Petition Number: Insert Zoning Petition #2021-042
General Location Identifier: 14125107 & 14125108

04/29/2021 First Review (KP)

Transportation Summary

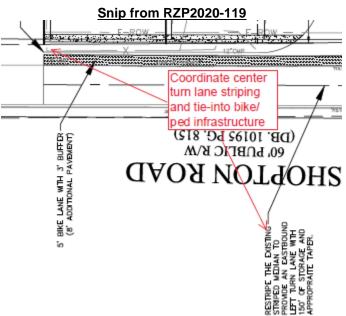
8. Revise the site plan and conditional notes to commit to connecting the bicycle and pedestrian infrastructure, as well as the center-left turn lane striping, into the previously approved infrastructure and striping associated with RZP 2020-119 adjacent to this petition. The infrastructure and striping will be designed and constructed in accordance with CDOT and NCDOT standards.

Note: It will be beneficial to coordinate with 2020-119 as soon as possible to mitigate any unnecessary/redundant striping associated with the center-left turn lane.
